**Verrill Dana Interior Renovations
16001
ADDENDUM # 1
ISSUE DATE: October 10, 2016**

ADDENDUM #1

This addendum provides clarifications, additions and design changes to the architectural, structural, mechanical and electrical "Issued for Construction" drawing set issued on 09-21-2016.

Drawing Number
A07.1

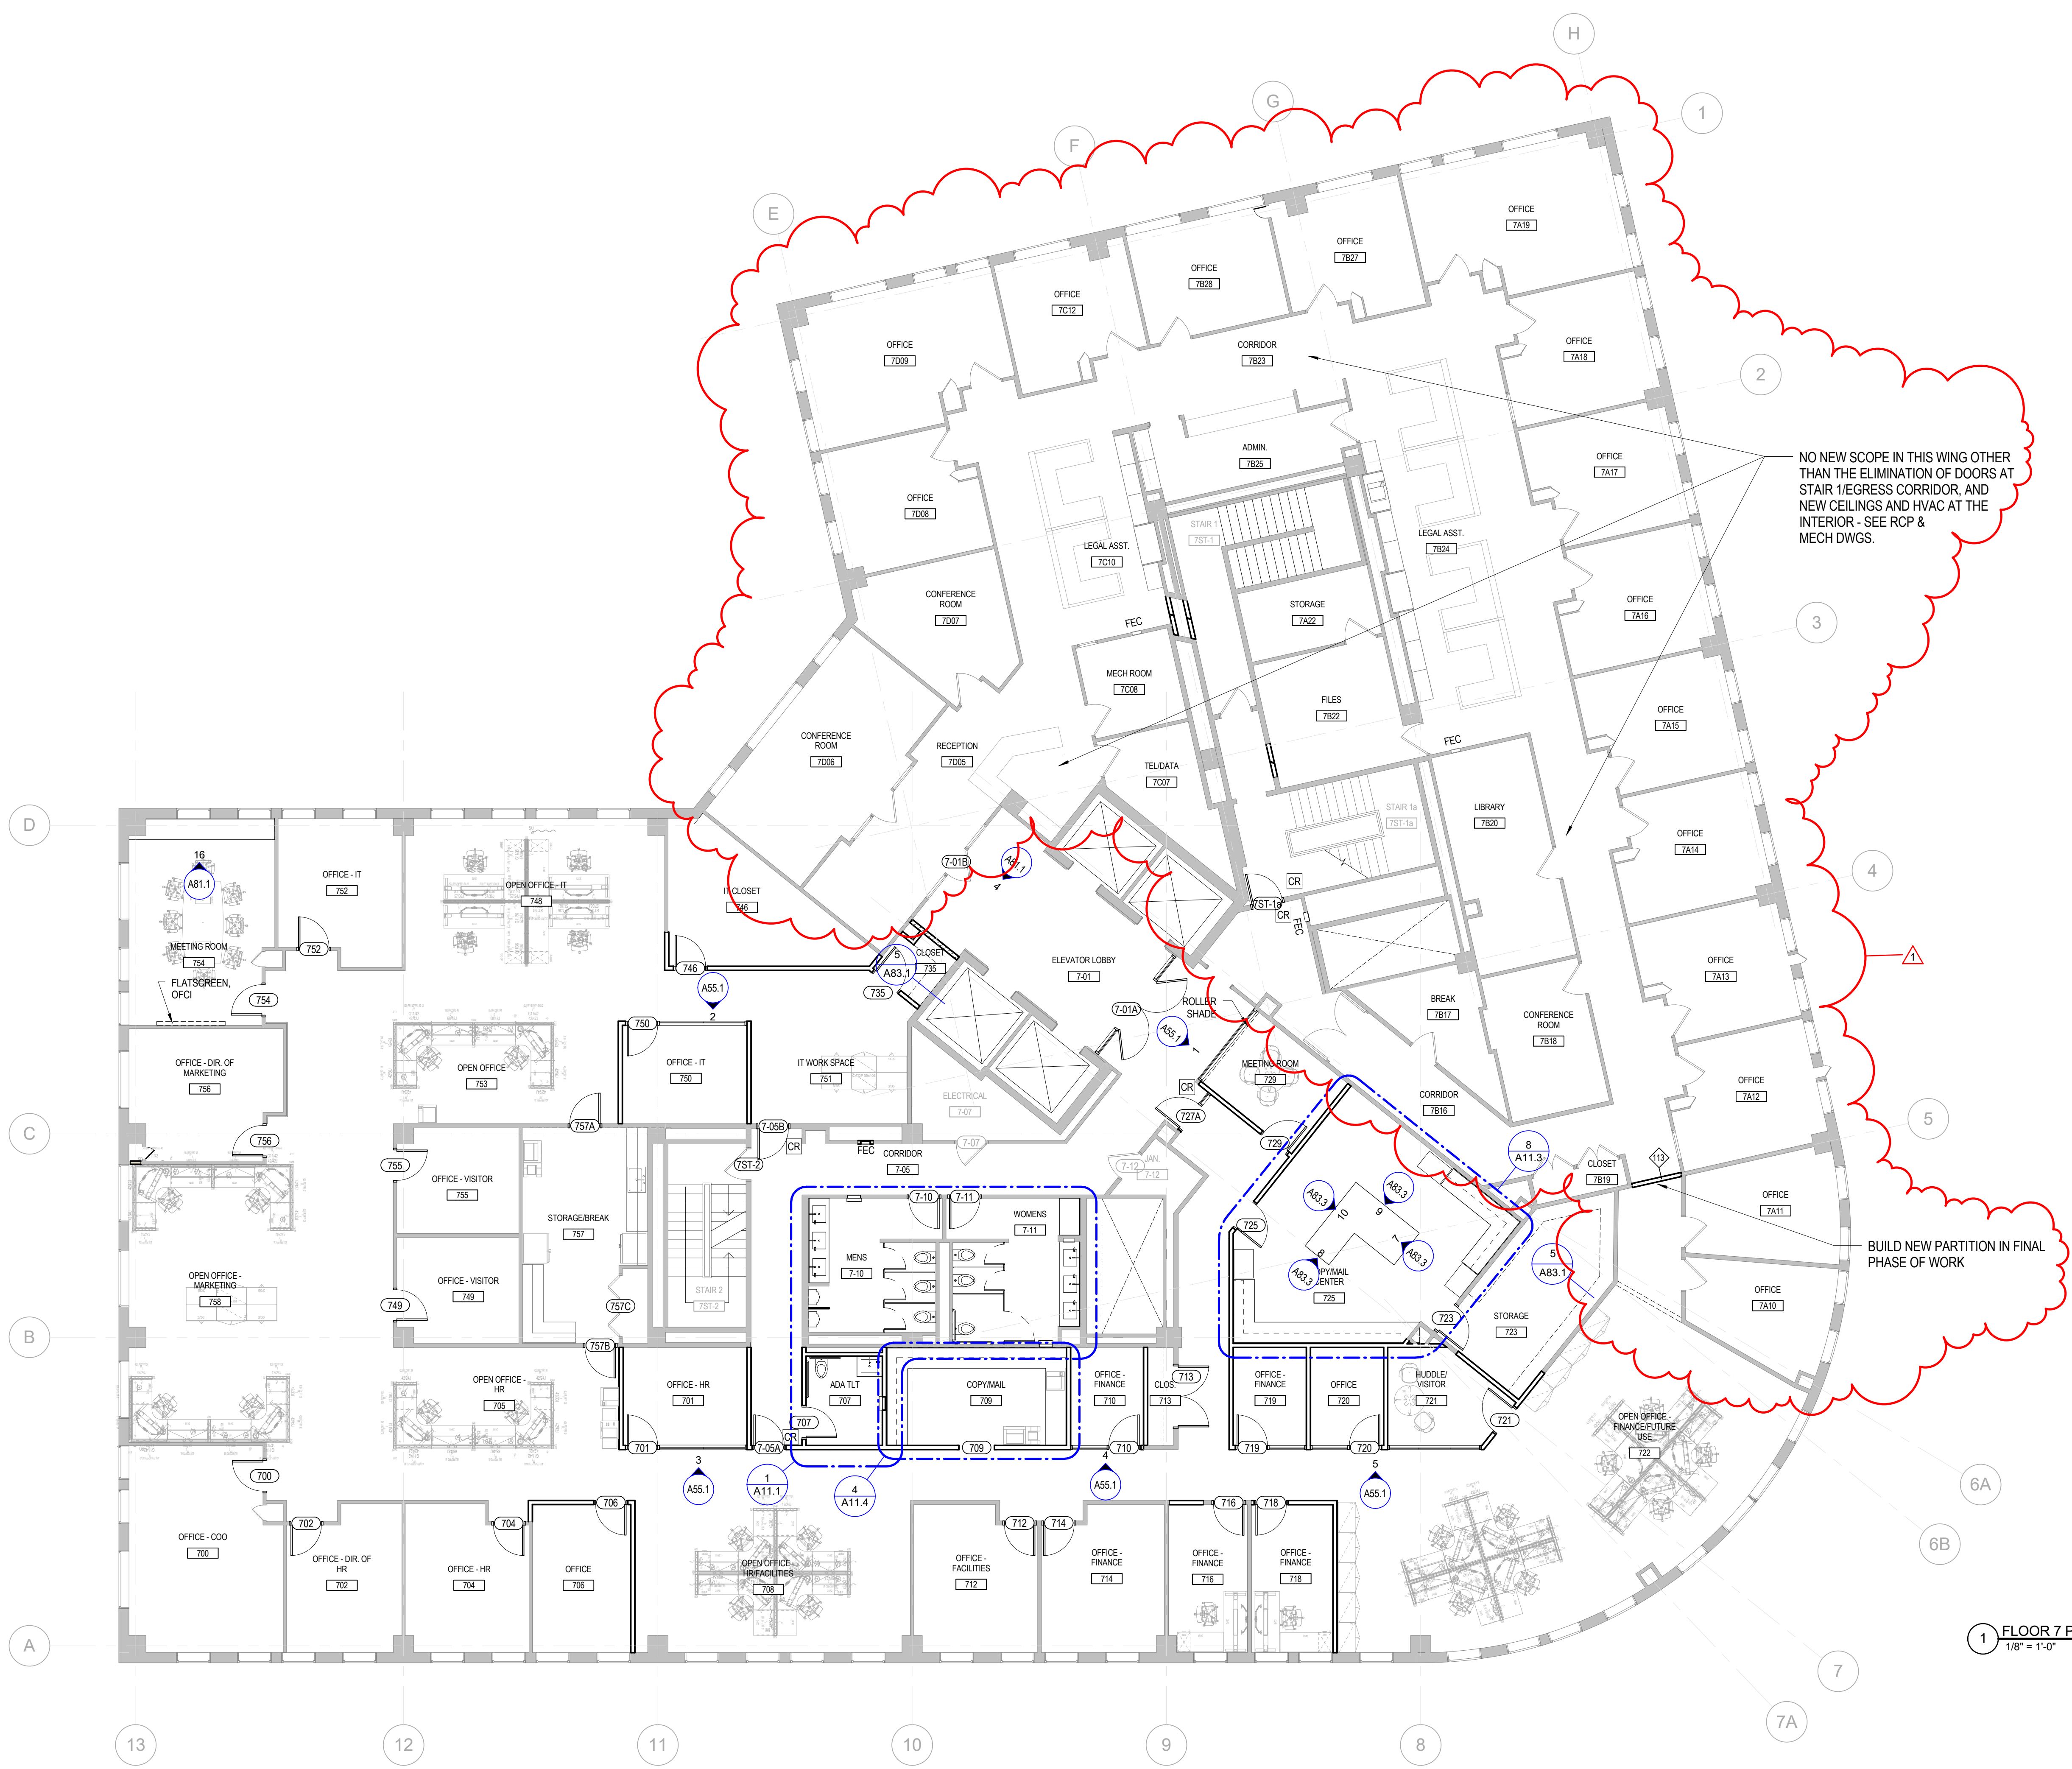
9. On sheet A07.1 Seventh Floor RCP Demo Plan has a note about removing recessed lighting but doesn't show any for a count like it does on the other floors. Should we assume a count of 12? Assume a count of 15 at 7th floor elevator lobby.
